10 Mb/s Single Twisted Pair Ethernet Auto-Negotiation Start Delimiter (Comments #182, #256)

Dirk Ziegelmeier
Steffen Graber
Pepperl+Fuchs

- Standard Clause 98 start delimiter:

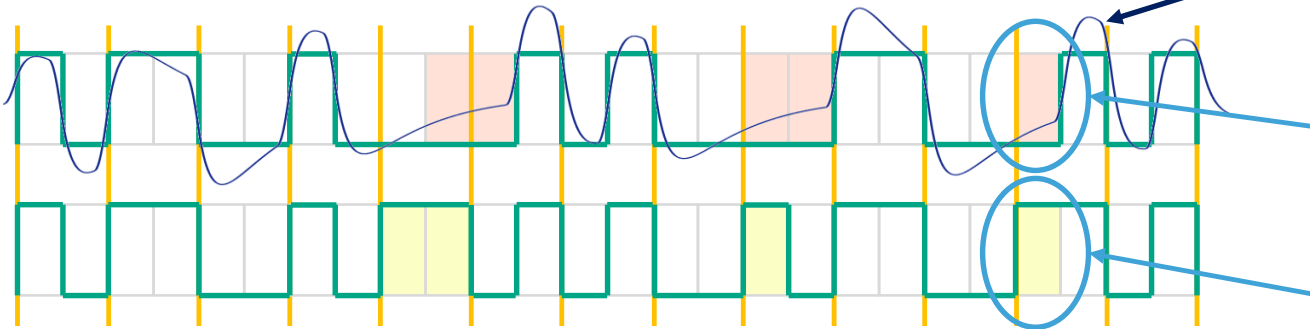
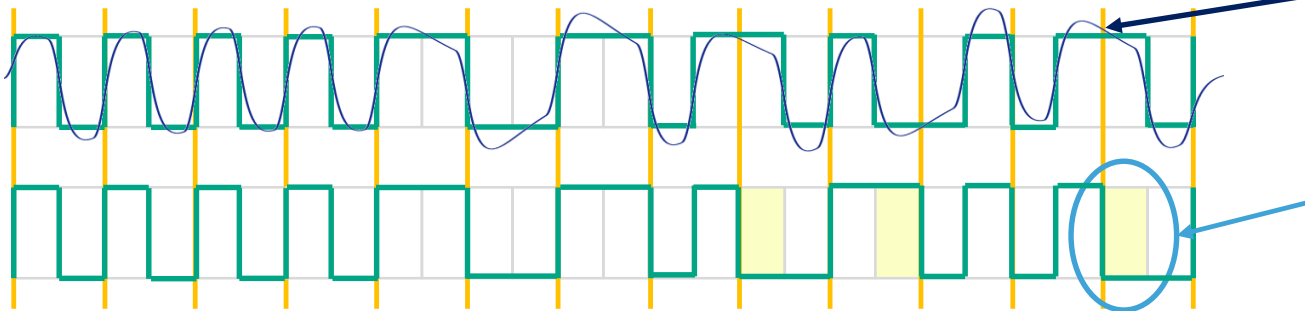
- The start delimiter specified in Clause 98 causes a **high BLW** at the receiver in combination with a 200 kHz high pass filter (which is used to filter out noise from SMPS or motor inverters; decreasing the filter value to e.g. 50 kHz, is for noise immunity reasons not really an option).
- Therefore detection of the start delimiter using a **correlator is quite bad**.
- A **simple detection** (e.g. using a shift register and comparator) **is prevented**.

- The proposed start delimiter causes **significant less BLW** (no longer pulses as normal DME signal).
- Only three instead of four code violations, but they are **better visible to the correlator**.
- A **simple detection** (e.g. using a shift register and comparator) **is possible**.

- **Therefore the suggestion is to change the start delimiter for the „low speed“ Auto-Negotiation to the proposed new one.**

Comparison

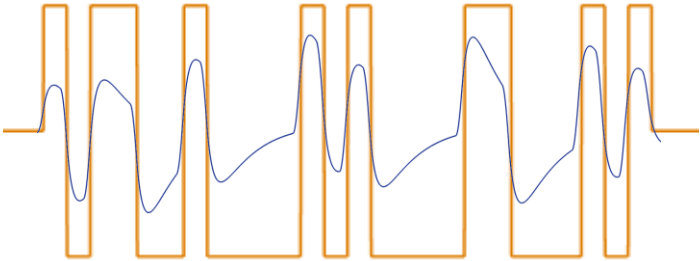
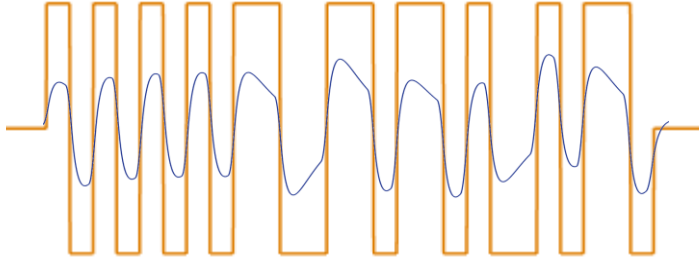
- The standard start delimiter has a quite high difference in the number of “+1” and „-1” pulses introducing a DC offset into the signal.

- The frequency range of the start delimiter is significantly lower than for the normal DME signal.

- The start delimiter causes a high amount of BLW in combination with the high pass filter in the receive path of a 10BASE-T1L PHY.

- Due to BLW reduced correlation properties (because of the BLW there are areas with no signal energy left after high pass filtering).

- Due to high amount of BLW need for a more complex synchronization of the receiver.

- A correlator/matched filter is needed for reliable detection of the start delimiter.

+ Good correlation properties, even if the high pass filter corner frequency is in a similar range than the Auto-Negotiation signal frequency.

+ The difference in the number of “+1” and “-1” pulses has been reduced compared to the standard start delimiter.

+ The frequency range is identical to the normal DME signal.

+ Significantly reduced BLW in combination with the high pass filter in the receive path of a 10BASE-T1L PHY.

+ Better correlation properties in combination with the high pass filter in the receive path of a 10BASE-T1L PHY.

- The proposed new start delimiter for Clause 98 low speed Auto-Negotiation mode has similar properties as the normal DME signal thus, in combination with the receive path filtering of a 10BASE-T1L PHY, providing reduced BLW and therefore an easier detection of the start delimiter and edge detector synchronization.
- Therefore it is proposed to change the start delimiter of Clause 98 to the new version for the low speed Auto-Negotiation mode.
